Supporting Statement – Section 96A Non-Material Amendment

Proposal: Amendment to the approved First Floor Layout Plan

Approved First Floor Plan Rev G (Incorrect measurement in Annex)

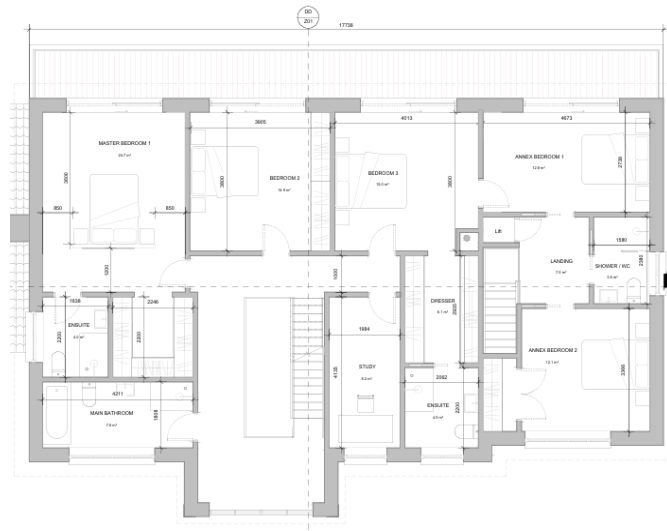
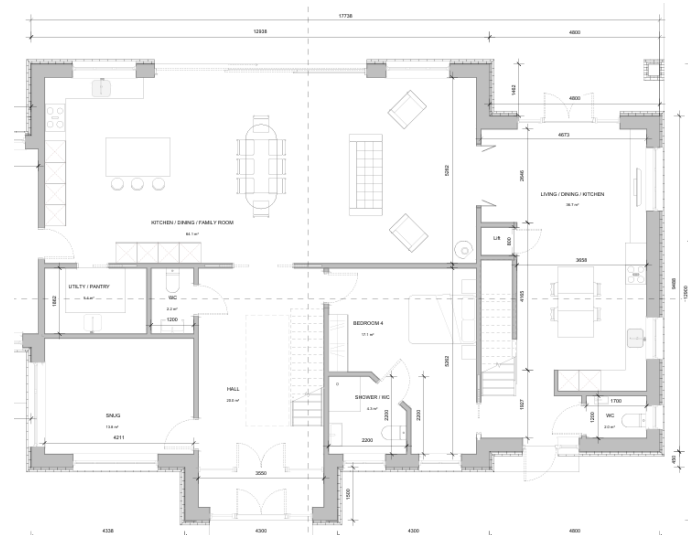
The proposed amendment is limited to the first-floor layout plan only. The approved drawing (First Floor Plan Revision G) currently shows the first-floor external wall to the Annex in an incorrect position, resulting in the first-floor area being shown as 800mm smaller in width compared to the approved ground floor, Second floor and elevation drawings.

The proposed amendment (First Floor Plan Revision I) will correct the position of the first-floor external wall and amend the associated dimensions on the first-floor layout plan so that the drawing accurately reflects the other approved drawing.
